ONE SYDNEY HARBOUR

BARANGAROO

R4A SUPPLEMENTARY DESIGN STATEMENT

June 2019

Podium West Facade (Above: previous; Below: propopsed)

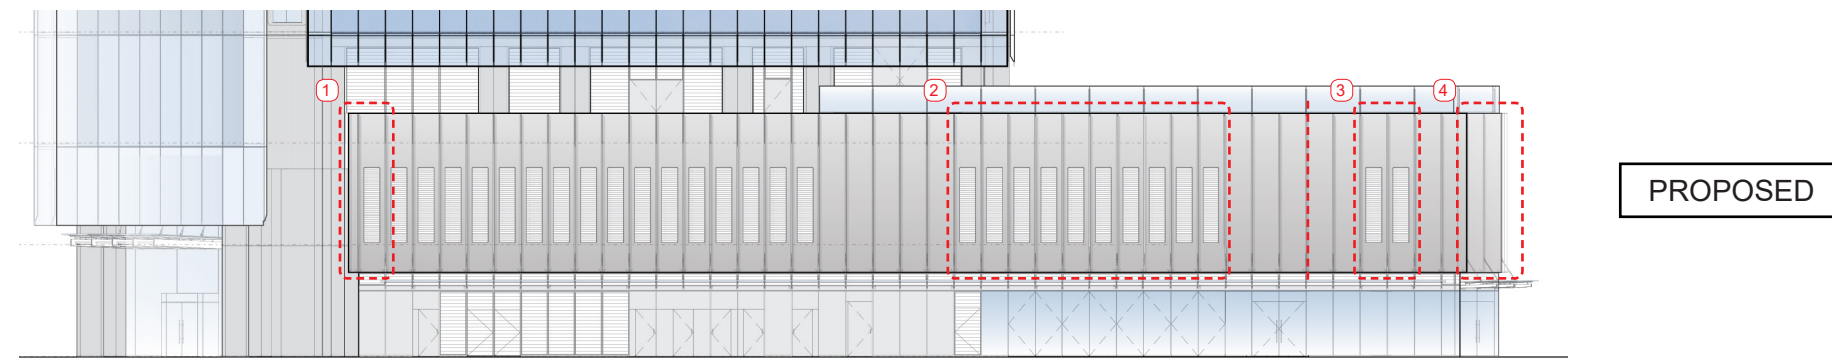
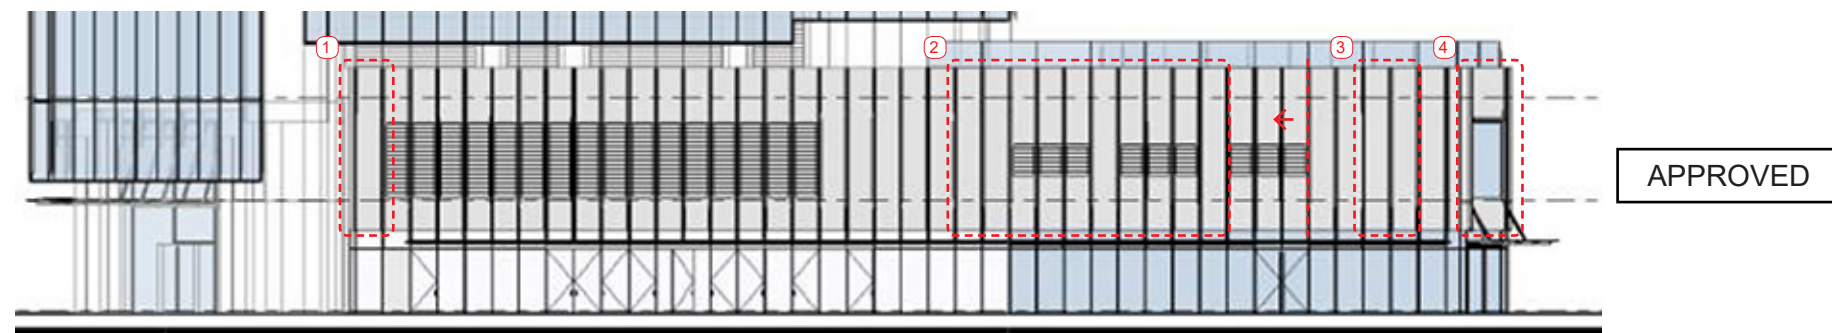
The modification proposes to refine the opaque podium facade modules. These refinements will improve the visual appearance of the facade and better meet the ventilation requirements of the substation and plantrooms. The proposed refinements are described as follows:

1. Addition of an extra louvre panel.
2. Relocation of the substation louvre panels, enlargement of those to match the adjoining ones, and addition of an extra louvre panel
3. Addition of two extra louvre panel.
4. Division of the approved large window panel on the podium tip into two regular opaque panels to match the rest of the podium facade.

Podium South East Facade (Above: previous; Below: propopsed)

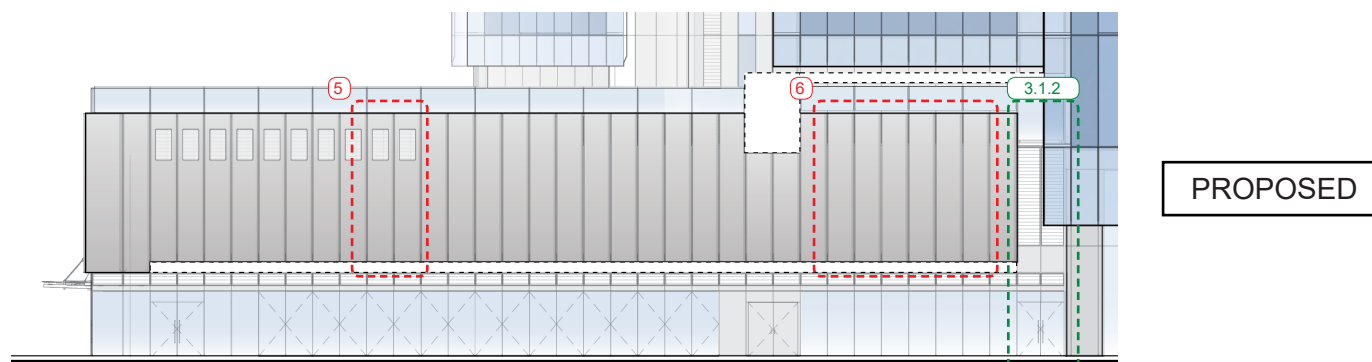
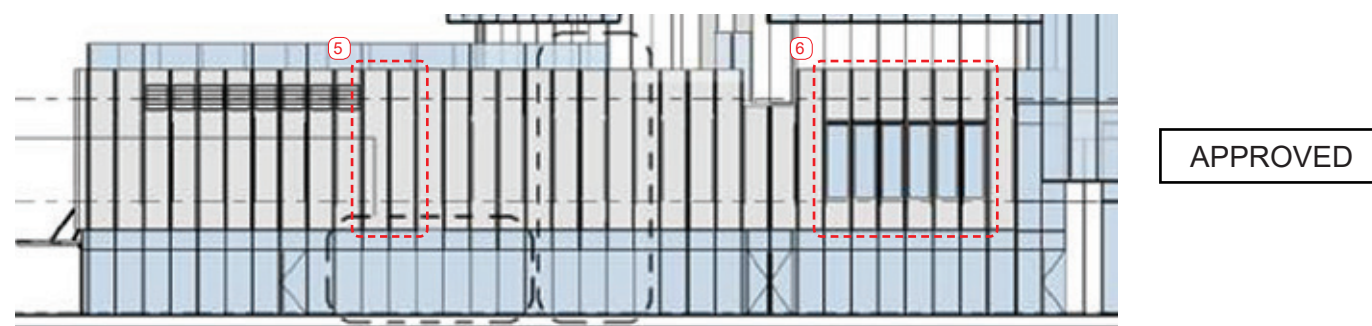
5. Addition of two extra louvre panels for the substation.
6. Replacement of 6 window panels with typical opaque panels so as to conceal the back-of-house space behind these panels.

Proposed Opaque Podium Panel

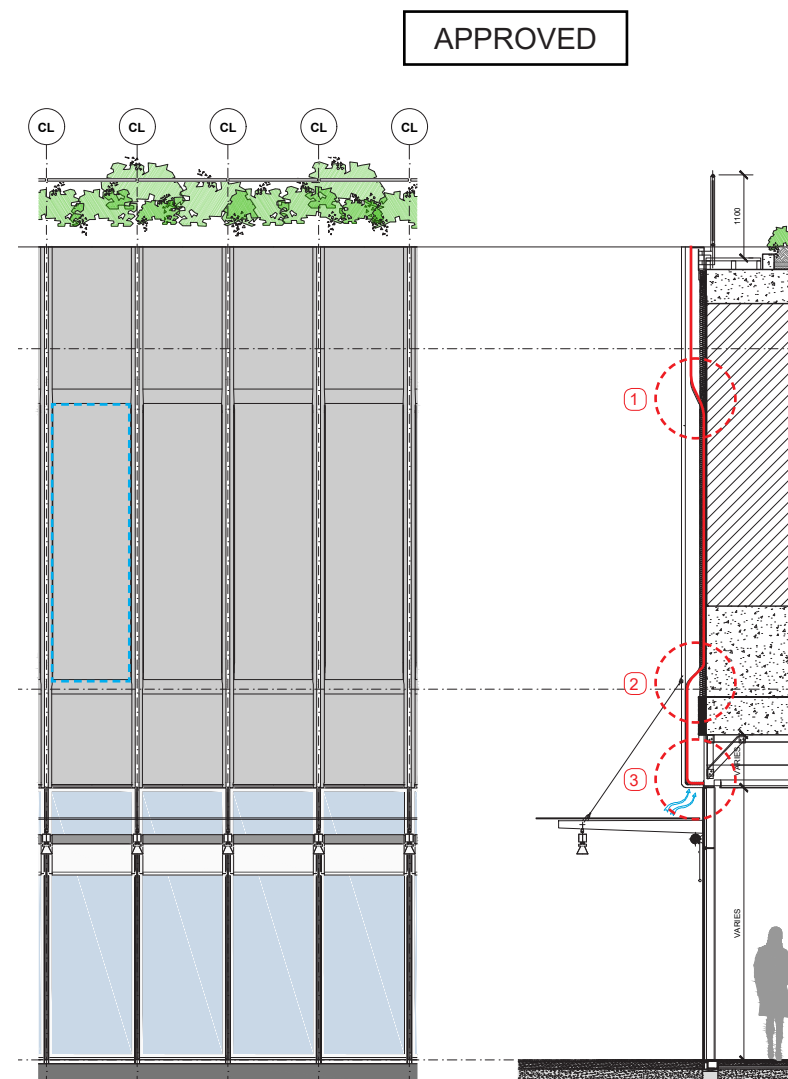
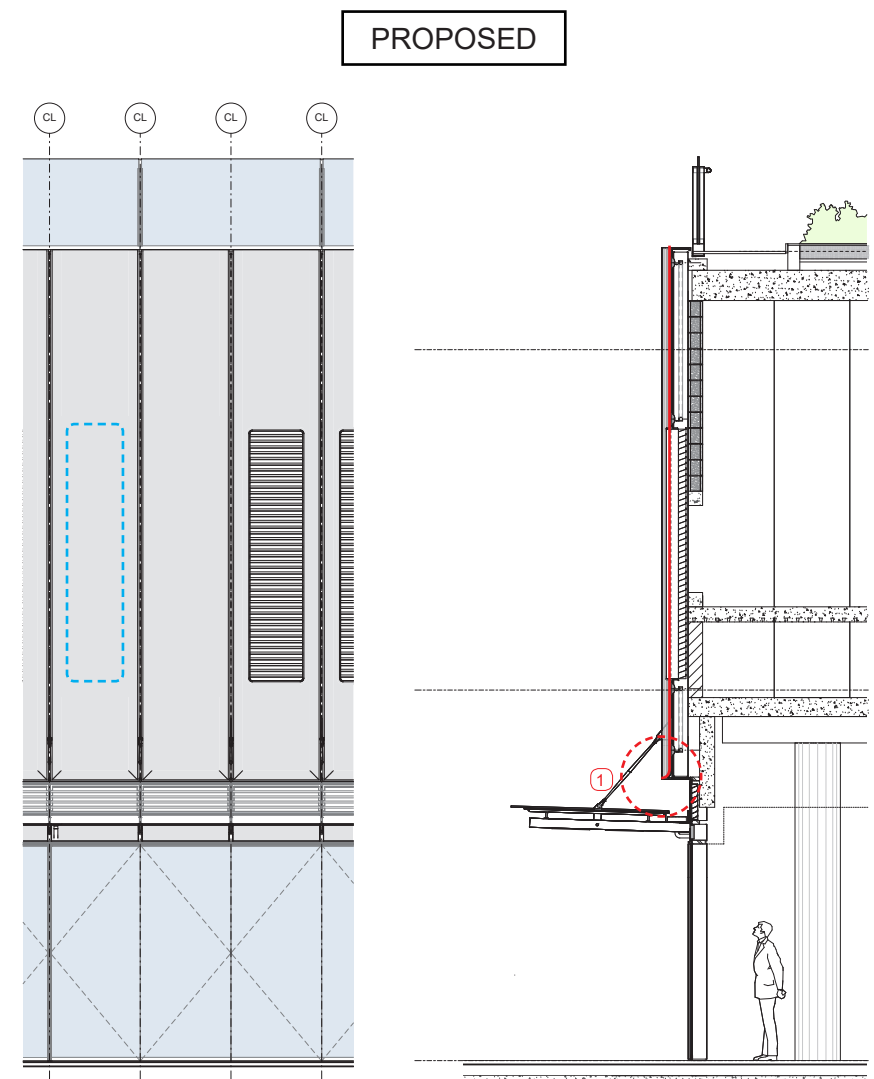
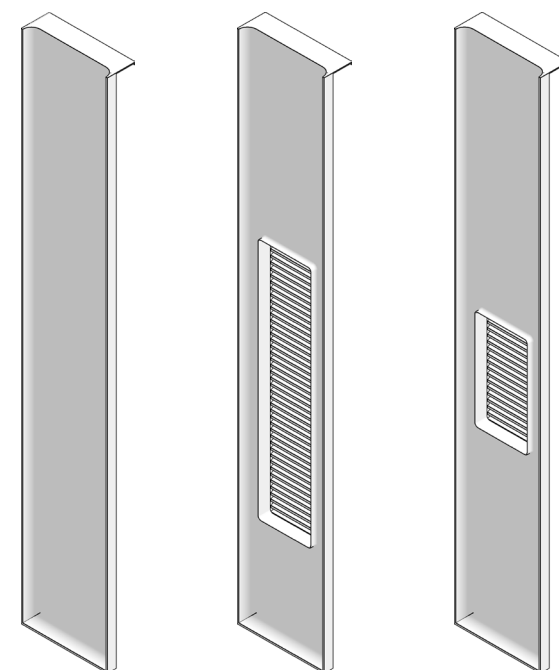
A key design change in the podium is the redesign of the vertical opaque cladding panels. During the post-approval design development phase, the curvature of the panel geometry was simplified in an effort to achieve a cleaner architectural form that better expresses the project's aesthetic principles of verticality, simplicity and lightness.

The panel geometry continues to allow for the required openings where needed, but in the updated panel design, the form of these openings are no longer reflected as physical impressions in the opaque panels (highlighted in blue in the adjacent elevations).

Proposed Lift Egress Facade - Elevation

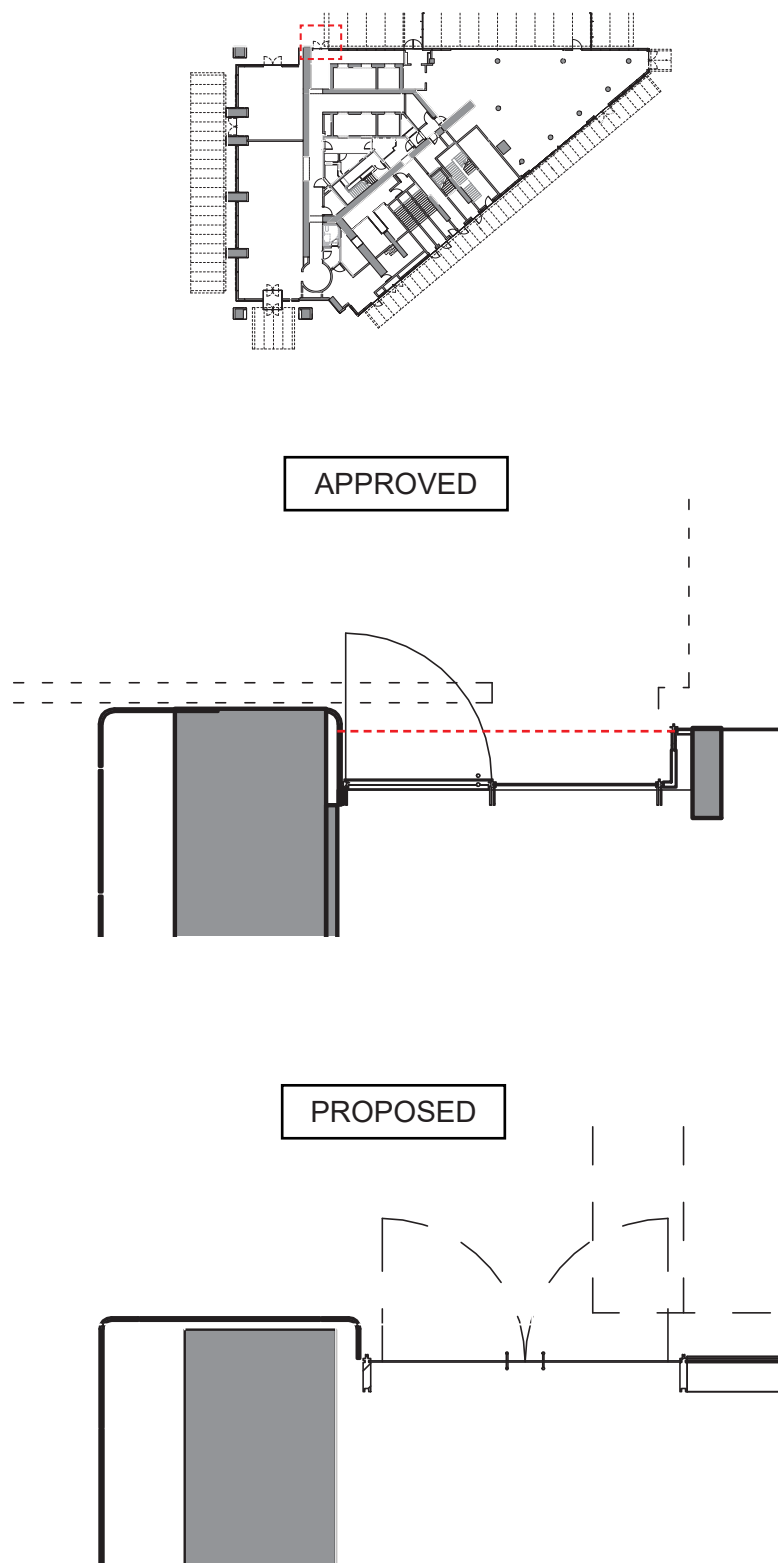
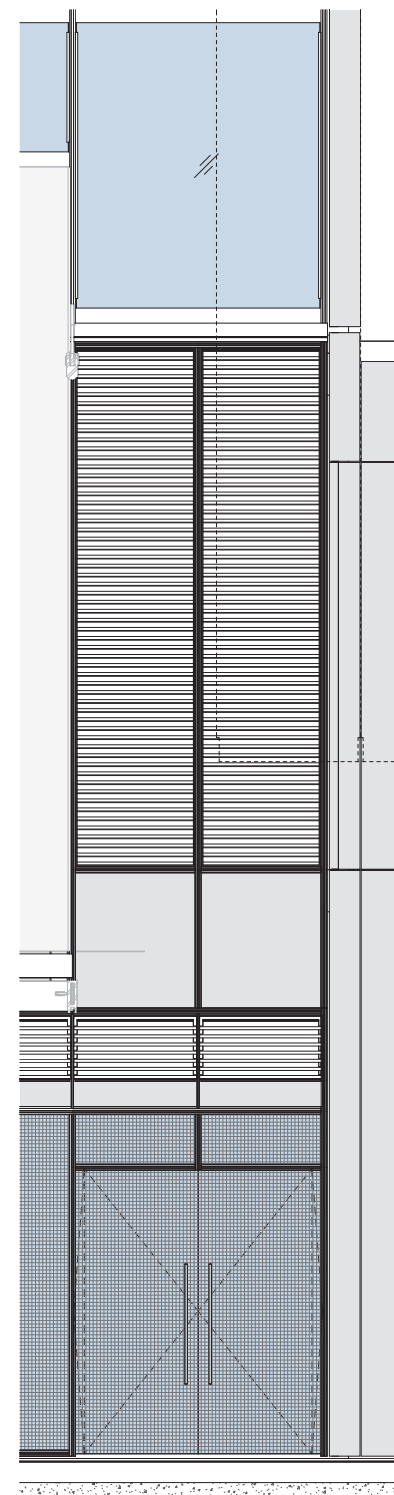
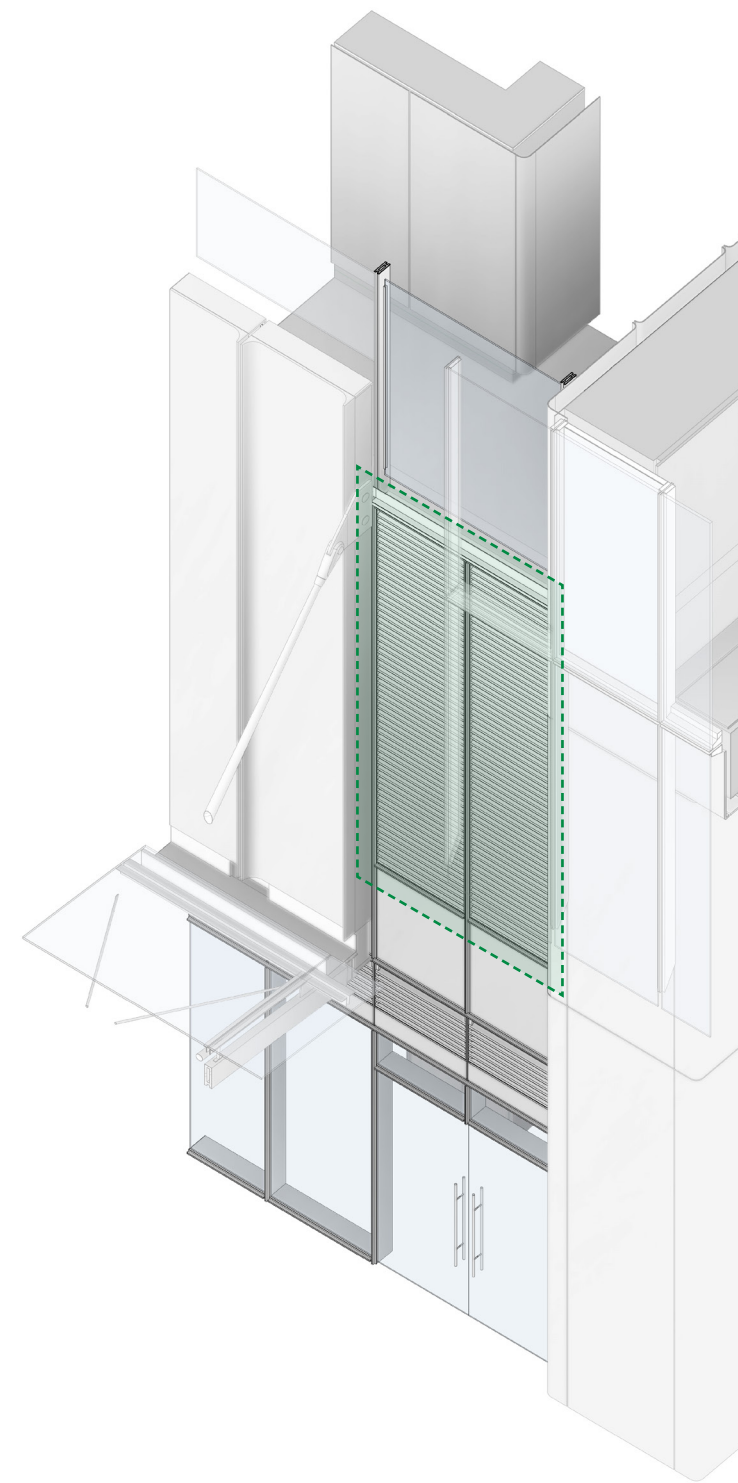
A series of minor amendments are proposed for the lift lobby facade egress doors. These include:

1. Alignment of the egress doors to the plane of the adjoining glass facade. This reduces the facade steps in that area and creates a visually cleaner interface with the column cladding that is adjacent to it.
2. Addition of a second door to the currently approved single door.
3. Addition of a louvre panel in the area highlighted in green in the adjacent 3D view. By contrast, the current approved design is an opaque glass spandrel panel.

Proposed Scheme for R4A-R4B Bridge

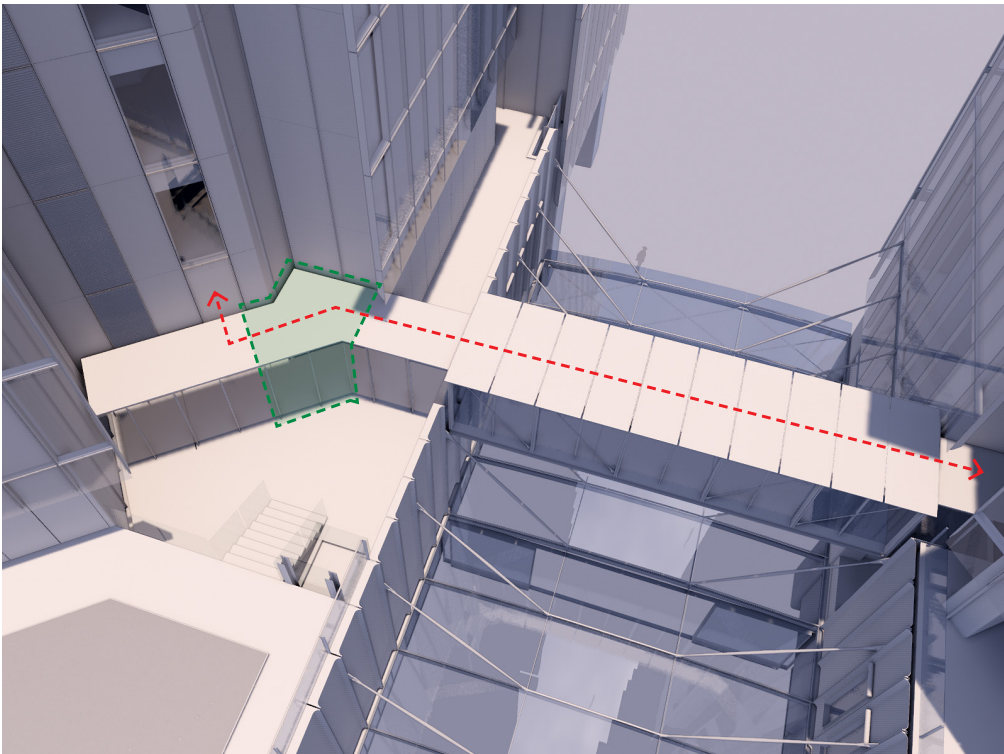
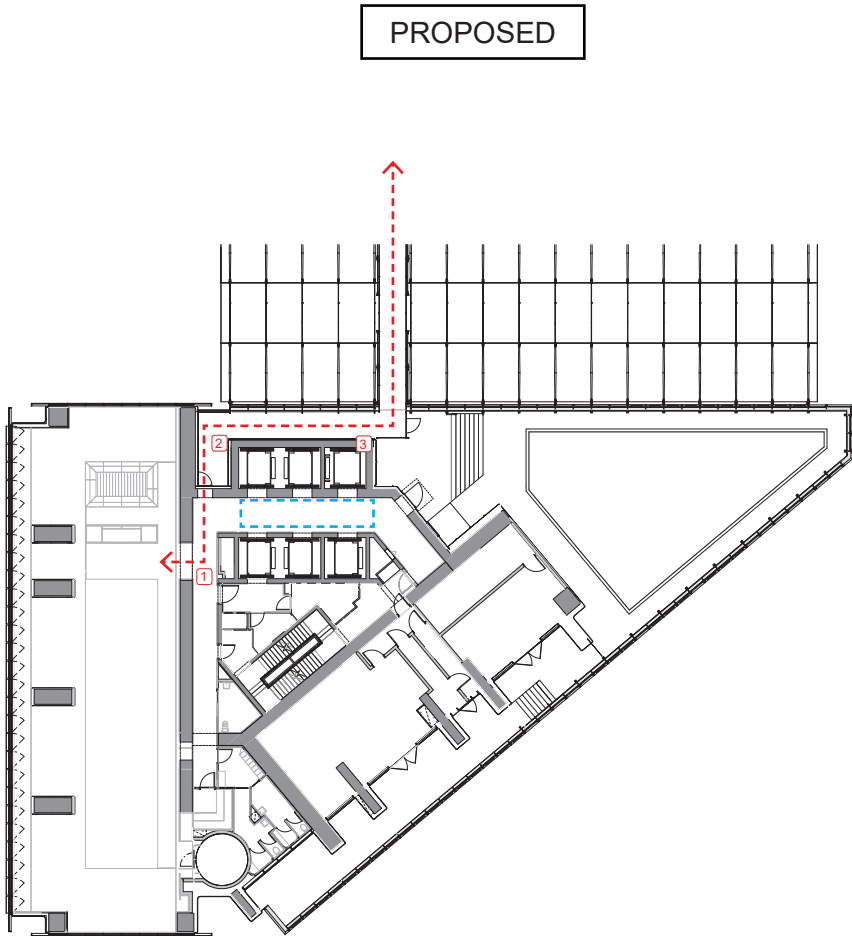
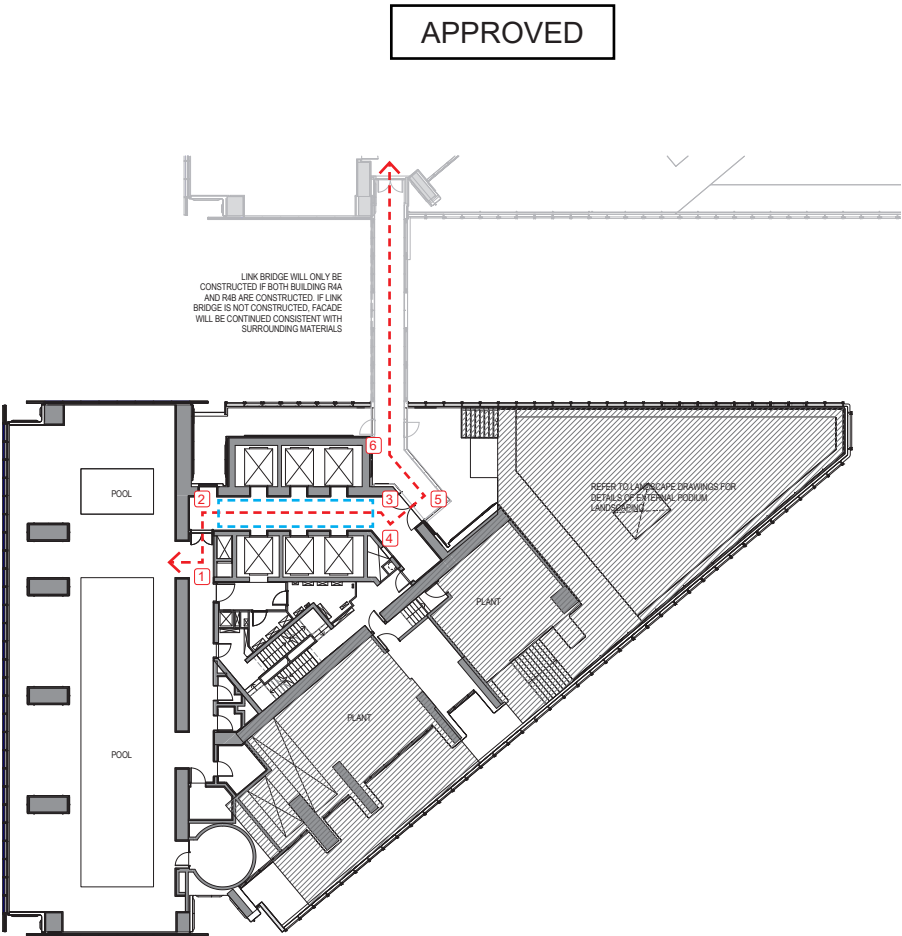
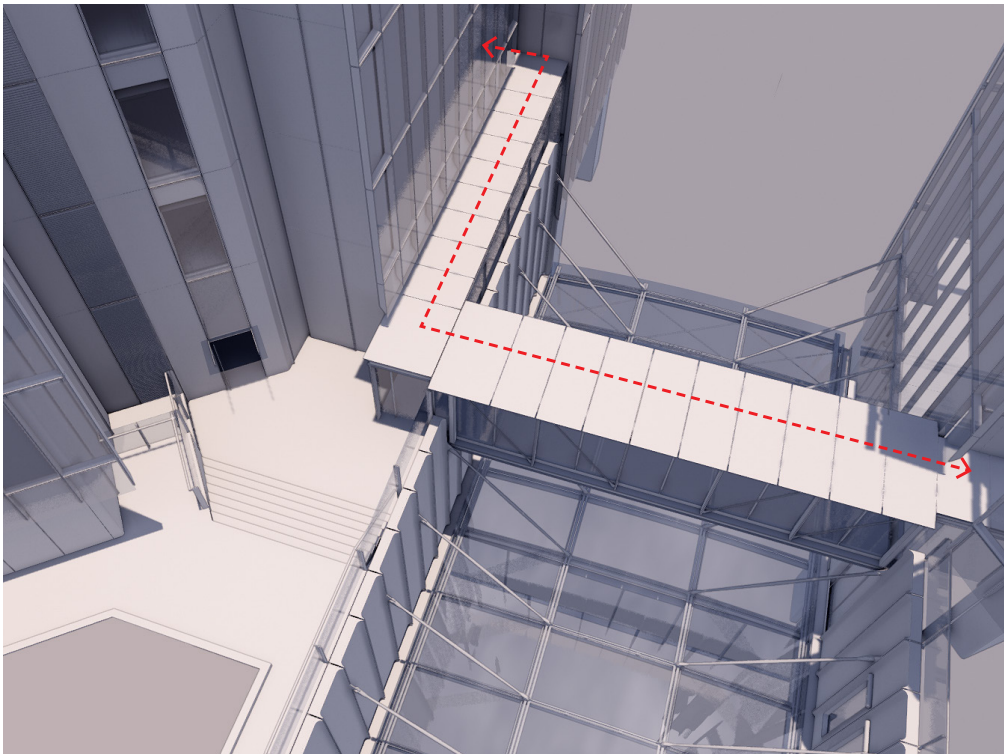
In an effort to develop a clearer connection between the R4A and R4B towers, the pedestrian bridge and its connections to R4A have been reviewed as part of the post-approval design development process. A new design has been developed that is more sympathetic to the geometry of the R4A external building form and the interior floor plan layout.

Firstly, it provides a simpler, more rational connection for its users. This is achieved by separating the path of travel of people crossing from one tower to another (highlighted by the dashed red lines) from those who are waiting in the lift lobby (highlighted by the blue rectangle).

Secondly, the proposed connection route avoids excessive turns, offering a more straightforward and user-friendly path from R4A to R4B. In doing so, the proposed path of travel avoids the angular connection that exists in the approved design (highlighted in green in the 3D images).

Under the proposed scheme, people will exit and enter both buildings from a similar point relative to the side facades of each tower which brings a conceptual clarity to the connection between the two buildings.
